Re: Change to the Mining and Reclamation Plan
Addendum to the Reclamation Plan for the East Mountain Emergency Drillpads
Genwal Resources, Inc., Crandall Canyon Mines, MRP C/015/032
Attachment 12

Title of Proposal: Addendum to the Reclamation Plan for the East Mountain
emergency rescue drillpads, Submittal of Attachment 12

COMPUTER GENERATED CUT/FILL REPRESENTATION OF REMAINING DRILLPAD RECLAMATION

AS-CONSTRUCTED CONTOURS FOR
REMAINING DRILL PAD RECLAMATION

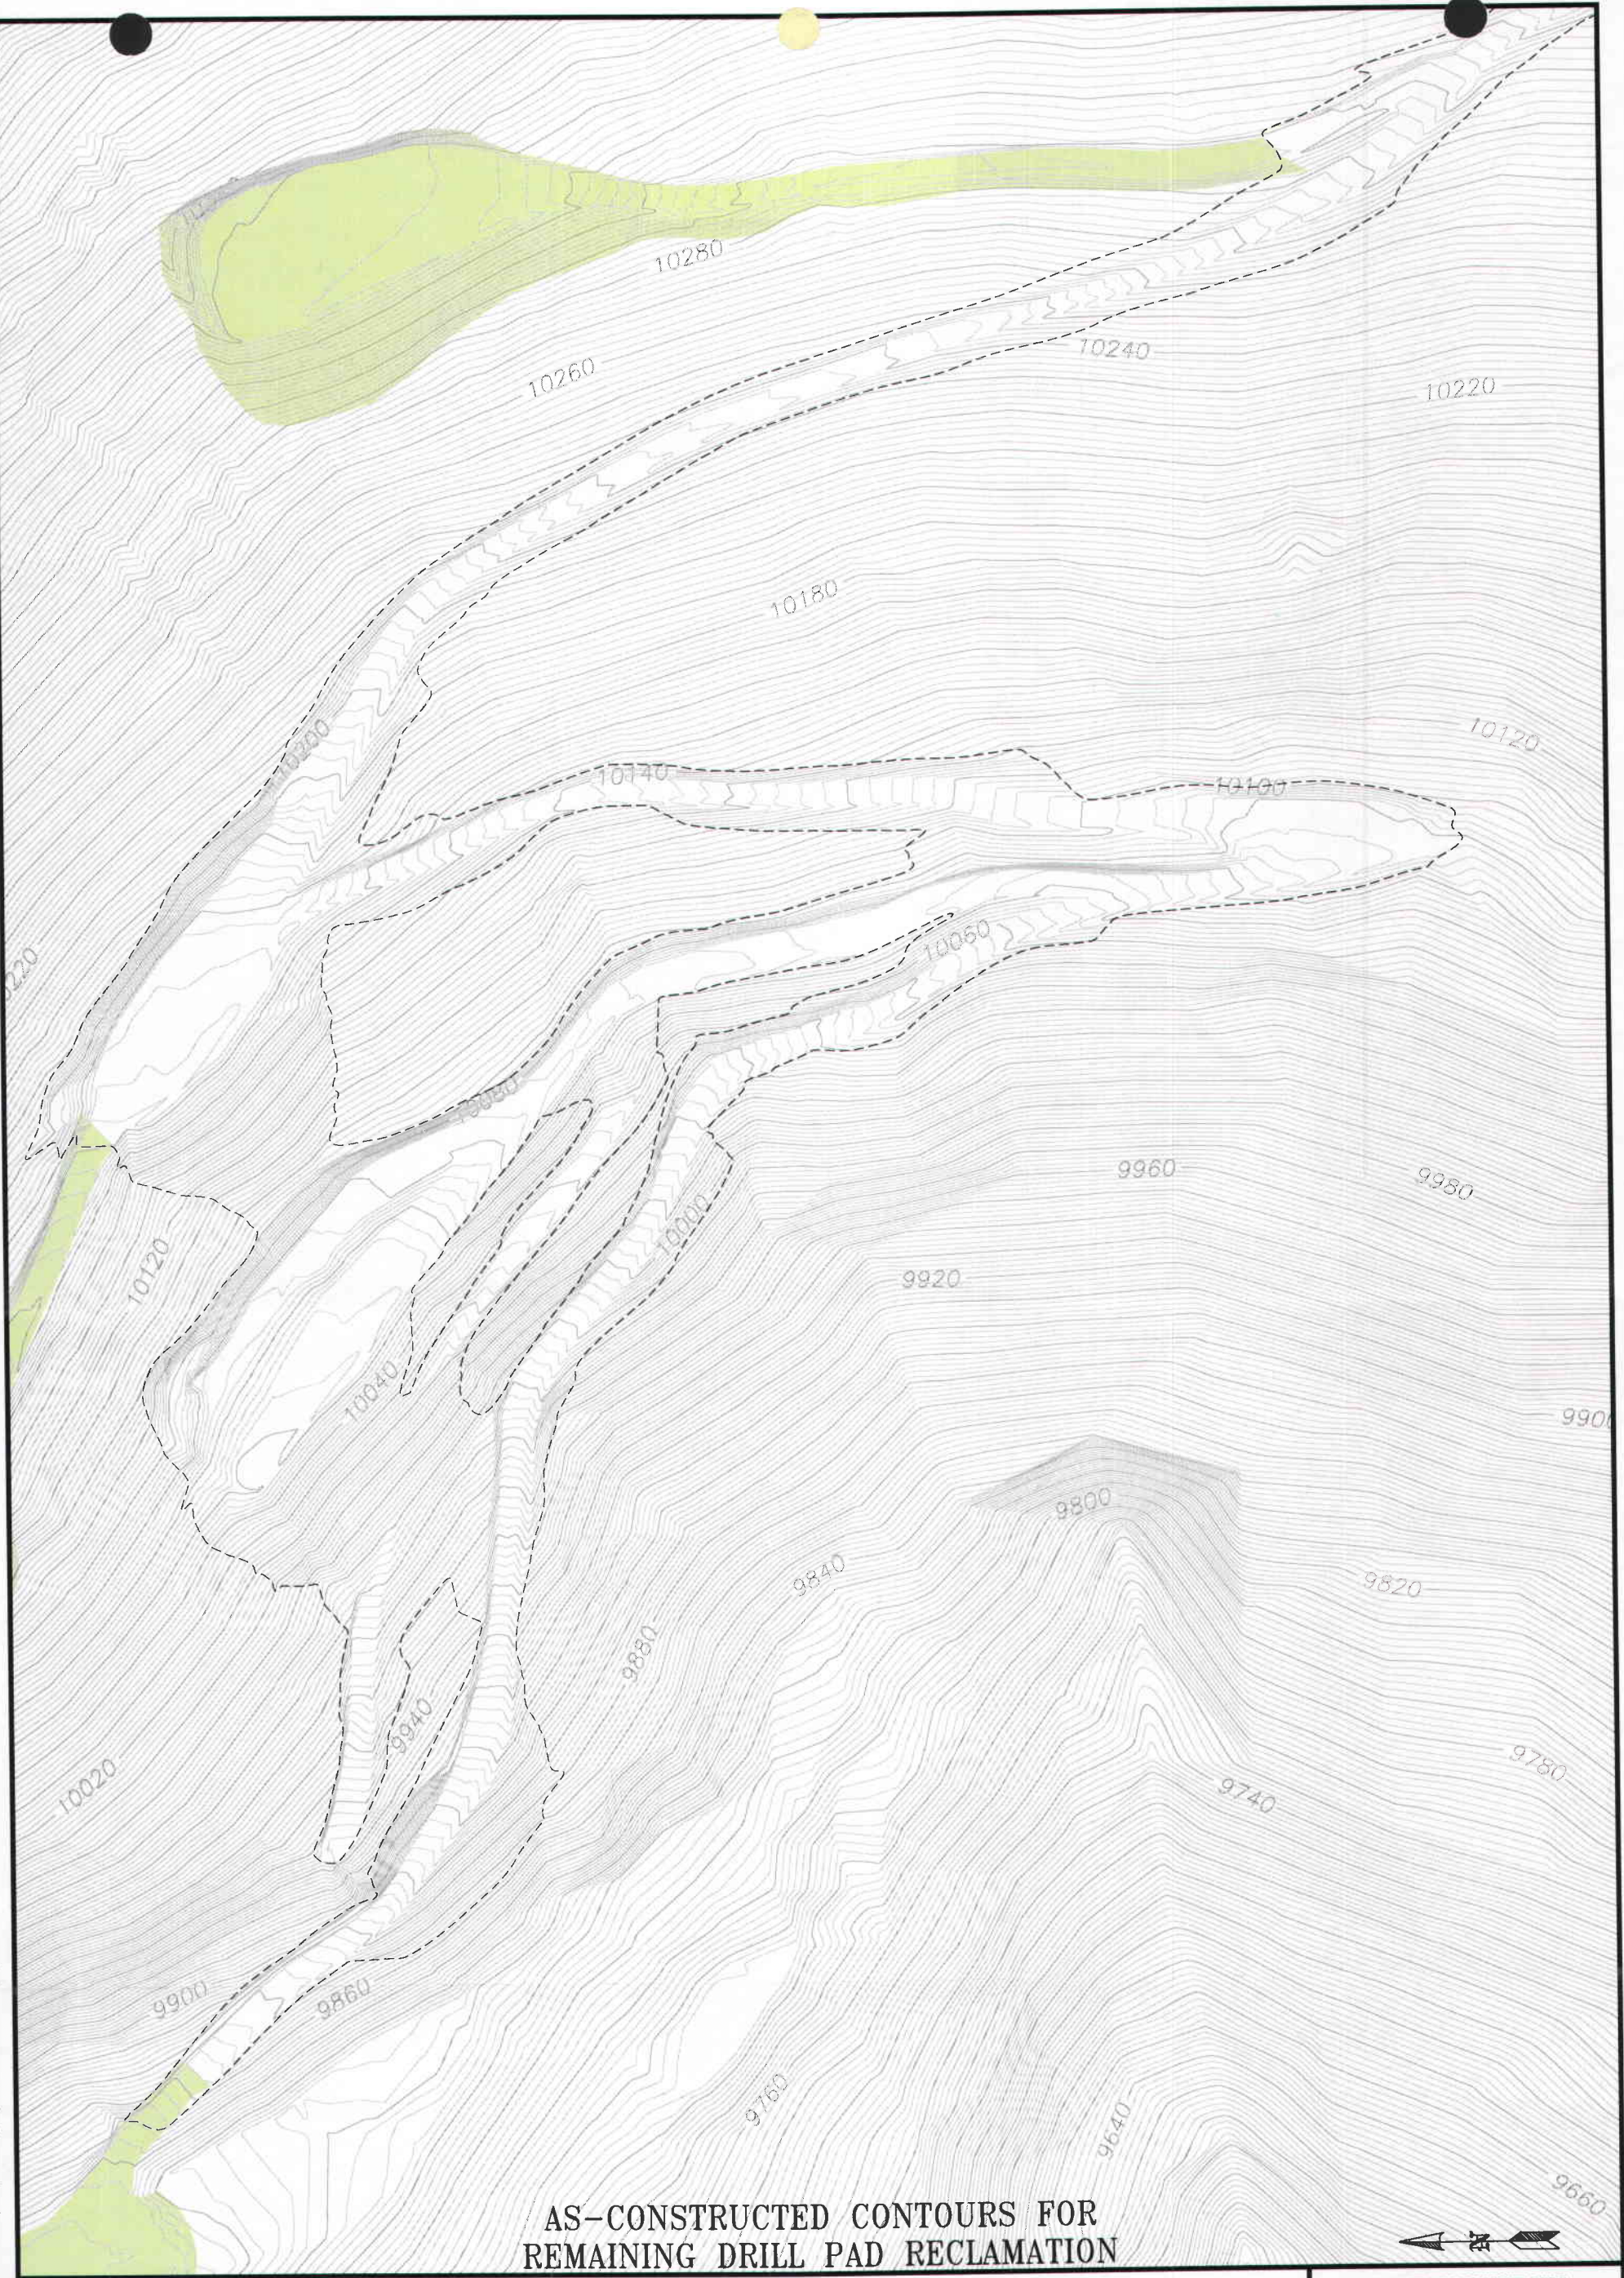
Enclosed please find seven (7) copies of Attachment 12, which is a computer generated cut/fill representation of the remaining drillpad reclamation. This information should be added to the East Mountain Emergency Drillpad Reclamation Plan. This additional information was requested by Priscilla Burton. C1/C2 forms are included.

Prior to beginning the reclamation work, Genwal Resources obtained digital mapping of the drillpads (with 2' contour accuracy) based on aerial surveys. Using this contour mapping as a base, and projecting imaginary "as-reclaimed" contours (attempting to replicate the approximate original contours), earthwork volumes were then generated by computer. The results of the computer simulation agreed closely enough with the field volume estimates to validate the projected cost estimates supplied by Scamp Excavation. See Attachment 12 for computer generated cut/fill representation of the remaining drillpad reclamation.
